RECREATION AVIATION ADMINISTRATION SOUTH AFRICA	RAASA Postnet Suite #118 Private Bag X1037 Germiston 1400
Telephone No: 011 827 9330 Facsimile No: 011 824 3517 Cell phone No: 076 875 4722 Email: info@raasa.co.za Web: www.raasa.co.za	Recreation Aviation Circular	RAC A02/09

Service Bulletin

Cheetah Aircraft elevator control stick hinge bolt inspection.

IMPORTANCE Before next flight
AREA AFFECTED Flight controls
SB SERIAL NUMBER Cheetah/001/09-2009

This is the M6 40mm high tensile steel bolt that requires attention

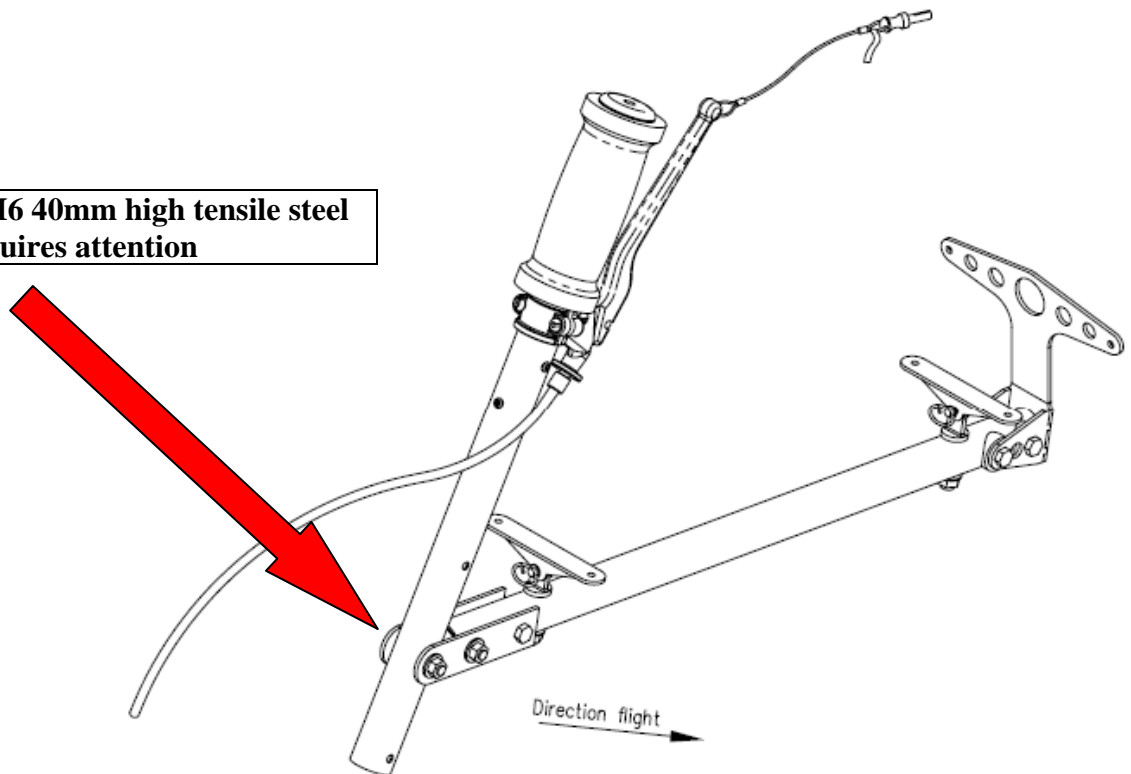
Failure of this part will cause loss of pitch control and failure of control of the Aircraft

Rainbow Aircraft has recently conducted a 500 Hour inspection on a Cheetah XLS. During the process of replacing an Elevator cable, it was found that the Elevator / Aileron control stick in the flight deck had a small amount of play. On further investigation it was found that the M6 40mm 8.8 high tensile steel bolt used as the pivoting point for elevator control, has worn away to allow play to form. The bolt has been inspected to determine the severity of the defect. The bolt has been found to have eroded away due to friction. This friction is induced by the cable tension from the elevator cables. **This situation is normal**

Immediate compliance: Inspect the Elevator control stick, hinge bolt for erosion (wear) as per accomplishment procedures.

Long term compliance: Replace this hinge bolt every 500 hours.

4. Inspect for erosion (wear) in the circumference of the bolt shank.

The erosion (wear) will be in the form of grooves forming on both ends of the shank.

If the bolt shank is smooth with no defects or wear it can be re fitted.

If there are any defects the bolt must be replaced. (See replacement parts)

5. with new Nylock in place torque to 10 Newton meter or 7.5 Pound feet
